Access Compliance Report Public Rights-of-Way (Curb Ramps)

Main Street: OAKTREE		Cross Street: ANTONIO_PKWY		Location:	SW
ADA ID: RPRK211019114044	Ramp Type: Type 4 - Parallel	Initial Pass/Fail: Fail	Overall Compliance: No	Severity Score:	30

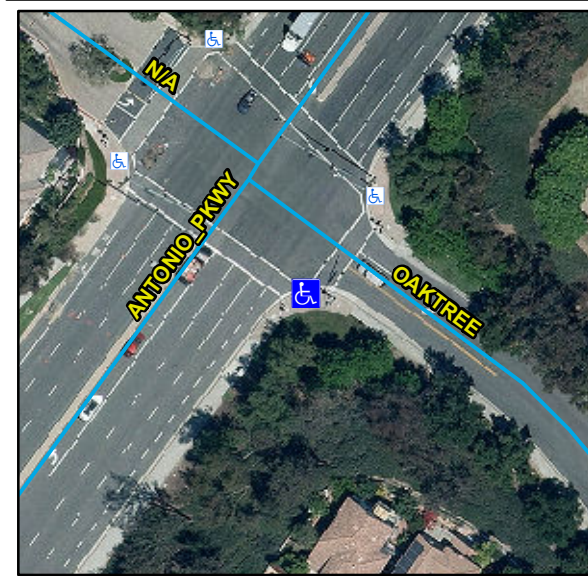
Remove & Replace Curb Ramp With Two New Directional Ramps or Equivalent. Grind Gutter Lip.

R204.3, R304.5.3, R302.7.2, STD 1115
